SUBJECT: Operational Reports - Lessons Learned, Engineer Units - 46th Bn, 84th Bn, 39th Bn, 34th Gp, and 36th Bn - for Period Ending 30 April 1971

SUBJECT: Operational Report - Lessons Learned, 46th Engineer  
Battalion (Construction), Period Ending 30 April 1971,  
RCS CSFOR-65 (R3).

9  
EGB-OP (20 May 71) 1st Ind  
SUBJECT: Operational Report--Lessons Learned, 46th Engineer Battalion  
(Construction), Period Ending 30 April 1971, RCS OR-65 (R3)

# 4-TON DROP HAMMER

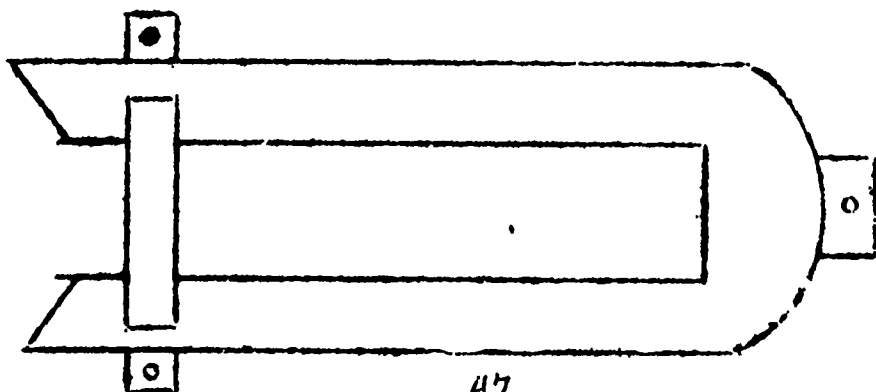
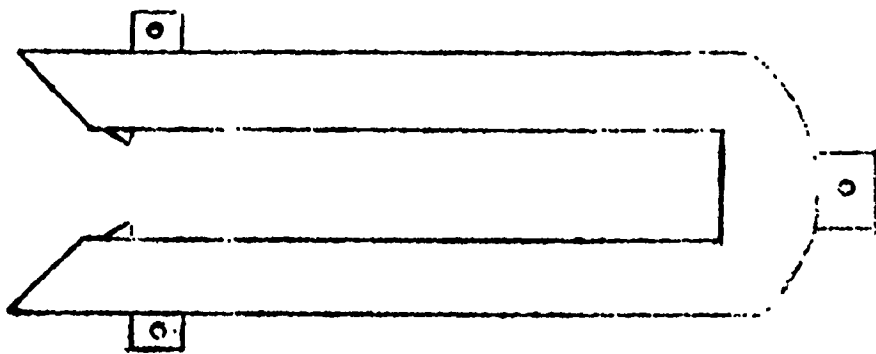
(b) Evaluation: The four (4) ton drop hammer has proven to be very efficient due to the fact that no time is wasted with leads. It is also very useful when starting long sheets where there is insufficient clearance between the top of the sheet and the tip of the boom to accommodate a deisel hammer. An extra advantage is that the hammer can be left set in place on the sheet pile should the crane be needed for another mission.

(d) Command Action: A hammer of this type was used to drive sheet pile at Bridges 1 and 6 LIL-74 with much success.
